Review of Plans: Rockland Homes for Heroes, 335 Western Highway, Tappan, Orangeburg, NY
Section 74.18 Block 3 Lot 48 R-15 zone
This matter is scheduled for:

Subject: **Camp Shanks Homes for Hero's Site Plan**
Prepreliminary/ Preliminary Site Plan,
Conditional Use Permit and SEQRA Review
335 Western Highway, Tappan
74.18/3/48; R-15 zoning district

PB#19-68: Camp Shanks Homes for Hero's Site Plan Permit #49045
Preliminary Site Plan Approval Subject
to Conditions/ Neg. Dec.

RE: Camp Shanks – RHFH Phase II Site Plan: The application of Rockland Homes for Heroes, owner, for Prepreliminary/ Preliminary/ Final Site Plan Review at a site to be known as “**Camp Shanks – RHFH Phase II Site**”, in accordance with Article 16 of the Town Law of the State of New York, the Land Development Regulations of the Town of Orangetown, Chapter 21A of the Code of the Town of Orangetown and to determine the environmental significance of the application pursuant to the requirements of the New York State Environmental Quality Review Act. The site is located at 335 Western Highway, Tappan, Town of Orangetown, Rockland County, New York, and as shown on the Orangetown Tax Map as Section 74.18, Block 3, Lot 4

TITLE:
**EXISTING CONDITIONS
AND DEMOLITION PLAN**

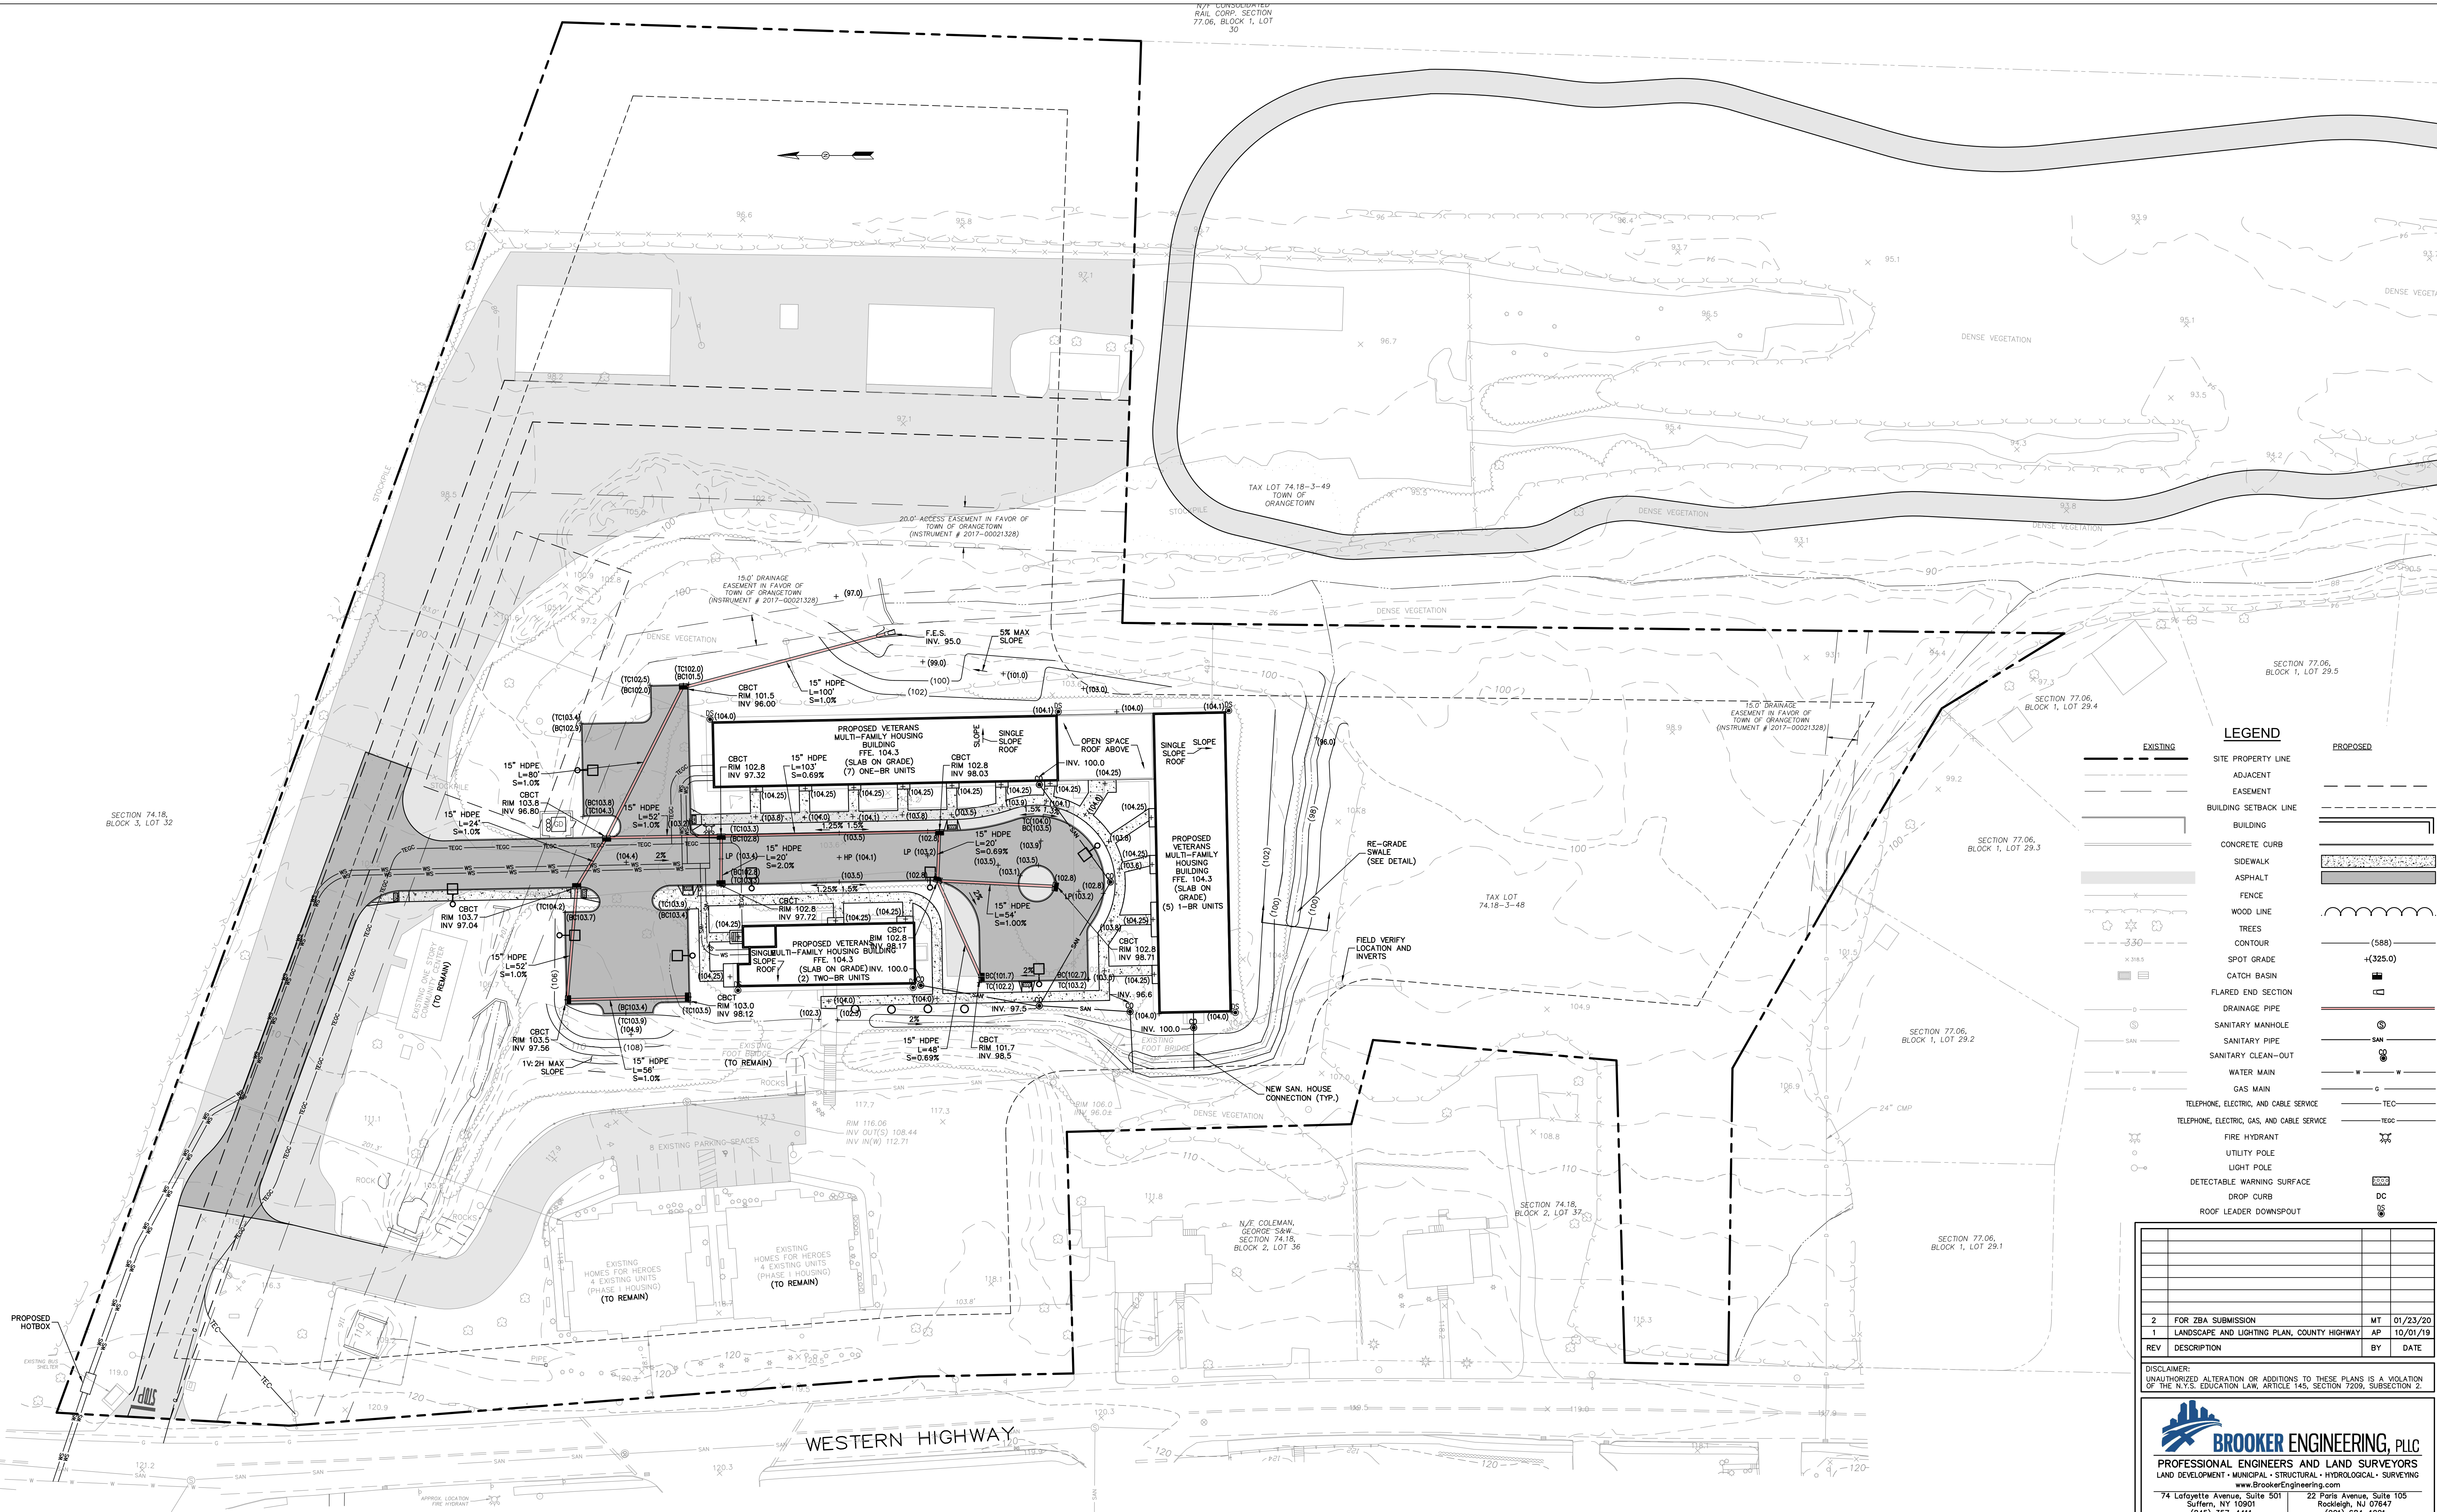
7. The amount of existing pavement to be removed shall be clearly delineated on the Site Plan.

12. The areas of existing pavement that are to be removed as part of this site plan, shall be clearly defined on drawings 2-5. A suggestion would be to show a special cross hatching in all areas of pavement that are to be removed.

TITLE: **SOIL EROSION & SEDIMENT CONTROL PLAN**

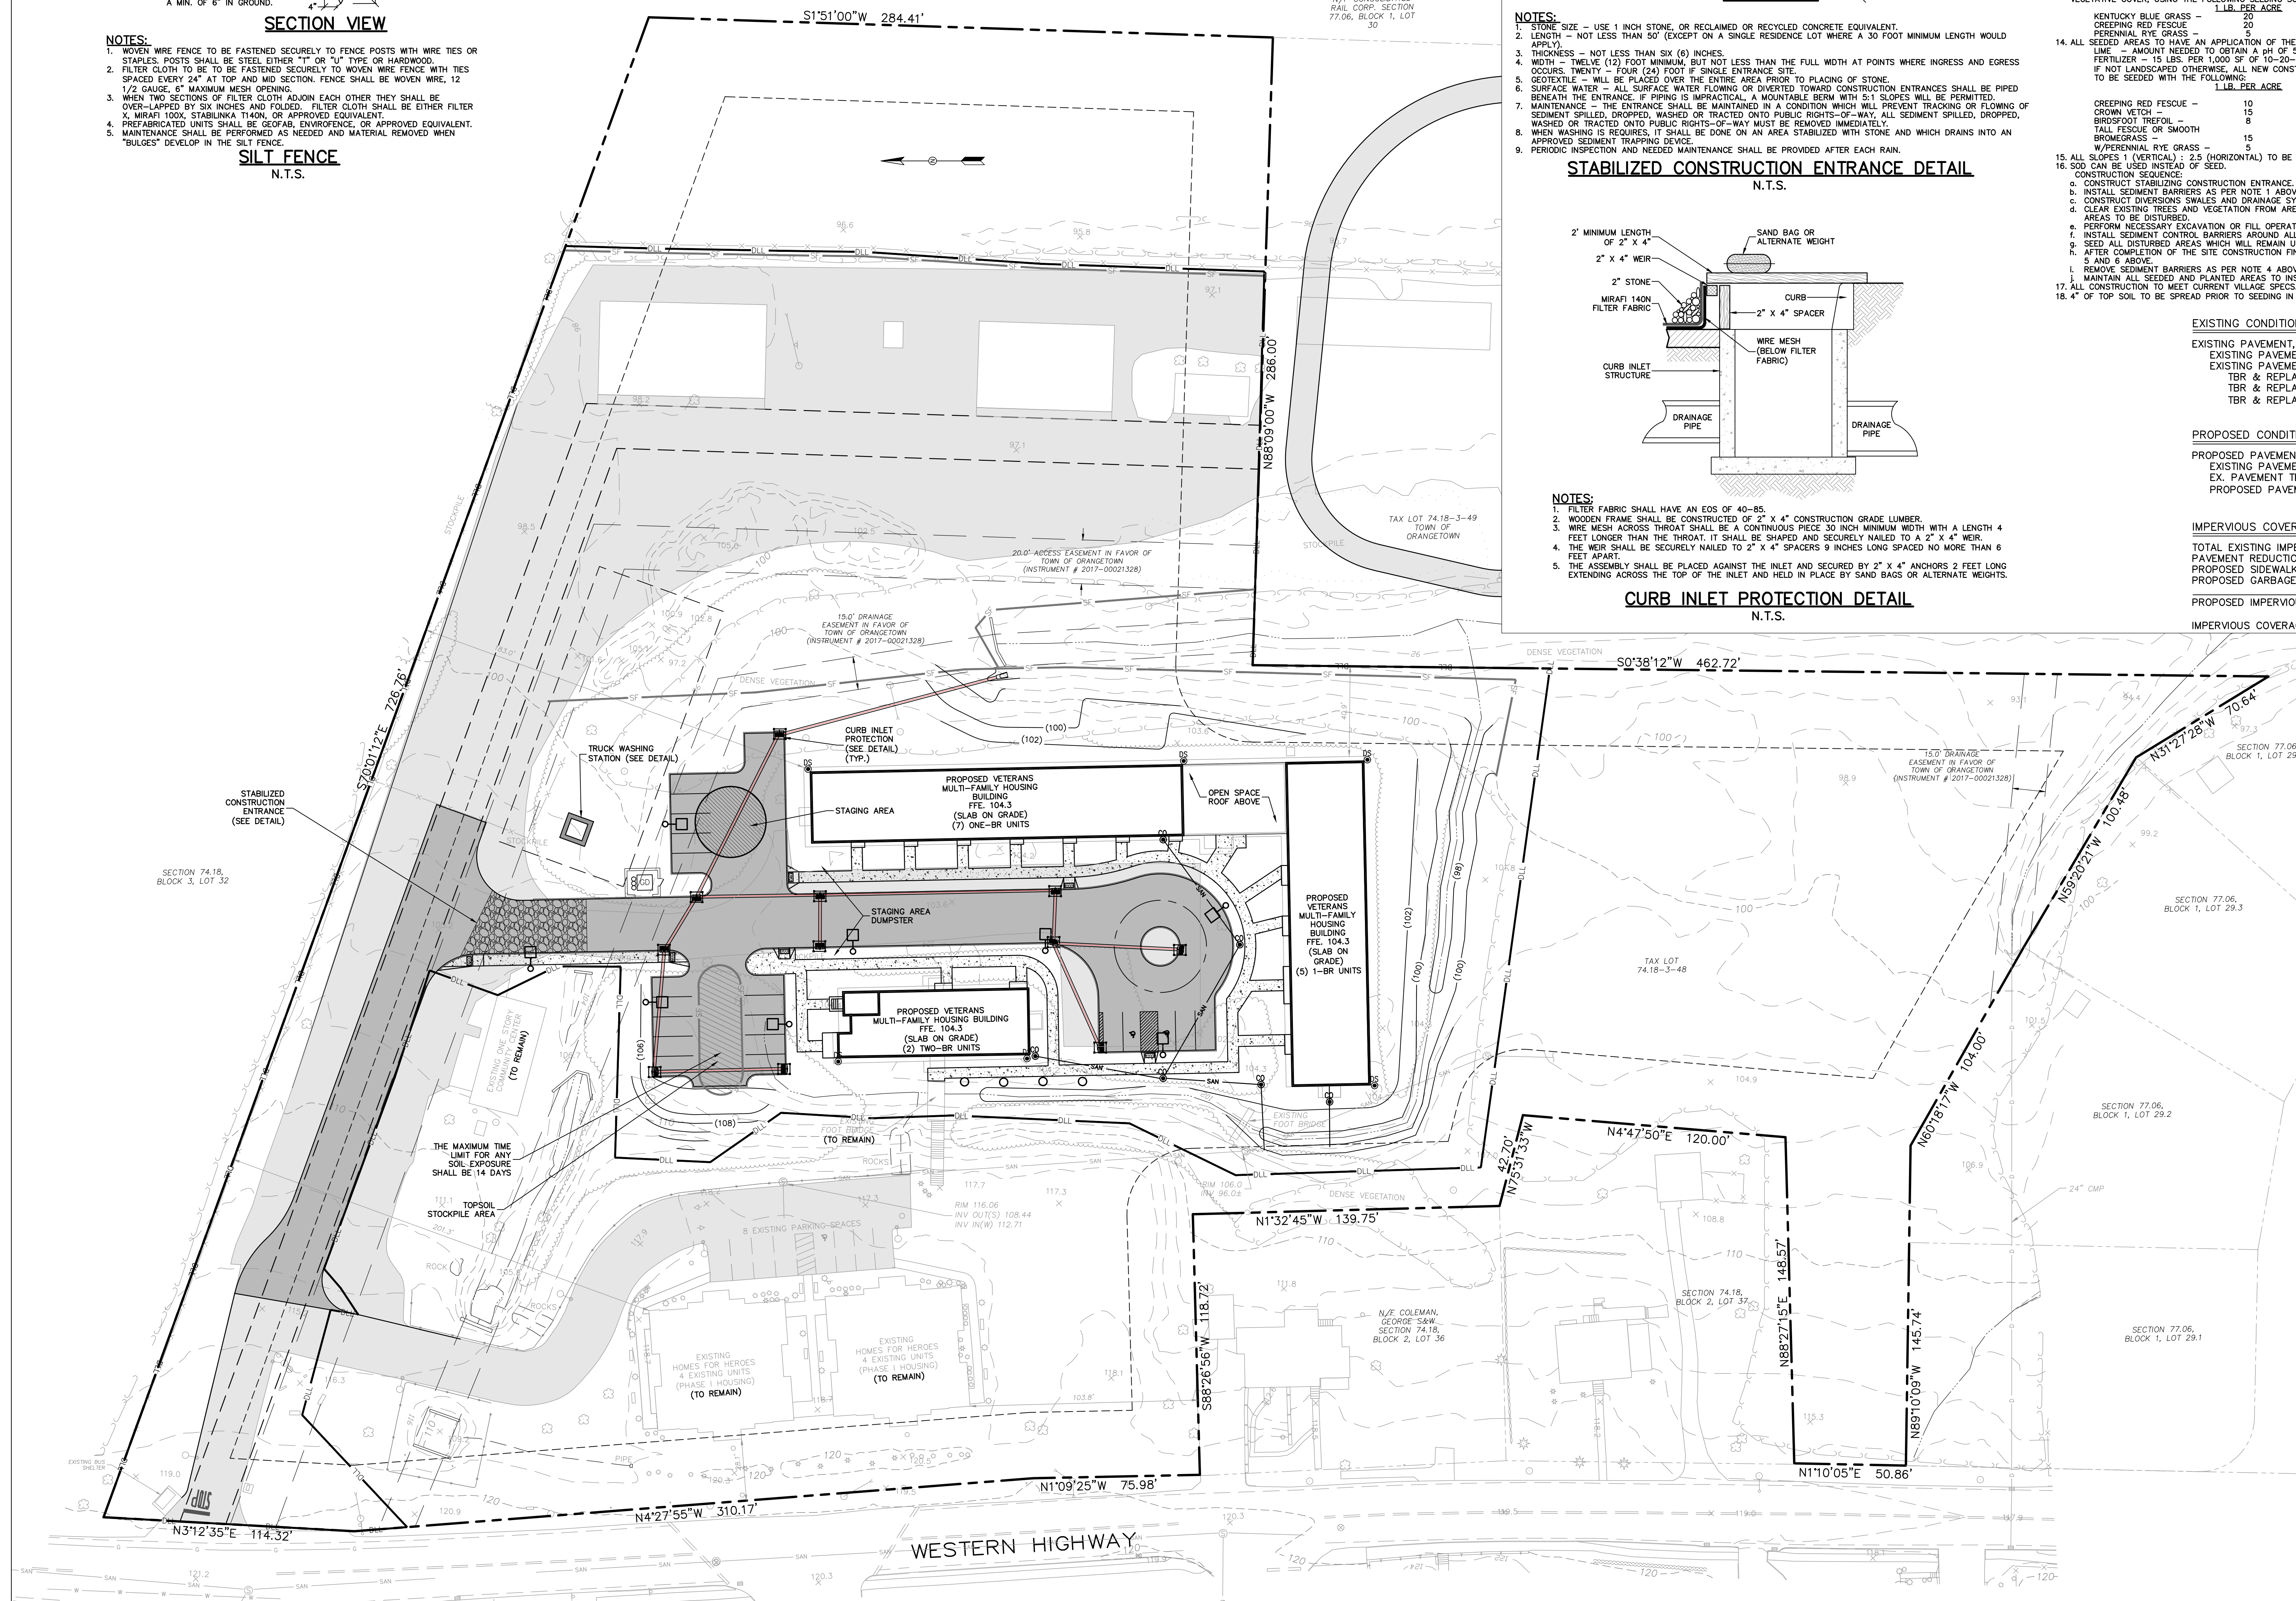
1. According to a note on Drawing 5 of the plans, the site in question is considered a redevelopment activity with an overall reduction in impervious coverage over 25% and therefore post construction water quality and quantity measures are not required. While the Drainage Consultant does not disagree with this approach for drainage on this project, this statement is not entirely accurate, and additional information is required to confirm.

2. Water Quantity controls such as Channel Protection and ten-year and hundred-year criteria would not apply IF the development activities result in no change to the hydrology that increase the discharge rate from the project. Therefore, a pre versus post comparison shall be provided to determine if that is indeed the case for this project.

3. Water Quality treatment objectives can be achieved by the reduction of existing impervious cover by a minimum of 25% of the total disturbed, impervious area. Please elaborate on the breakdown of the impervious surfaces to remain, to be removed, and to be replaced and/ or newly constructed shown in the table provided on Drawing 5. It would be helpful to key them to the areas on the plan so this can be reviewed and confirmed. It is also somewhat confusing in that there is an existing pavement total of 71,266 SF of impervious surface comprised of buildings but it is not clear. In order to claim this reduction, a clear graphic representation on the plans shall be provided, and it shall match the input numbers utilized in the pre versus post comparison requested in comment #2 above.

5. A SWPPP is still required based on the Area of Disturbance being 2.43 acres as indicated on Drawing 5, which is greater than 1 acre.

6. Please show the limit of disturbance graphically on the drawings, as well.
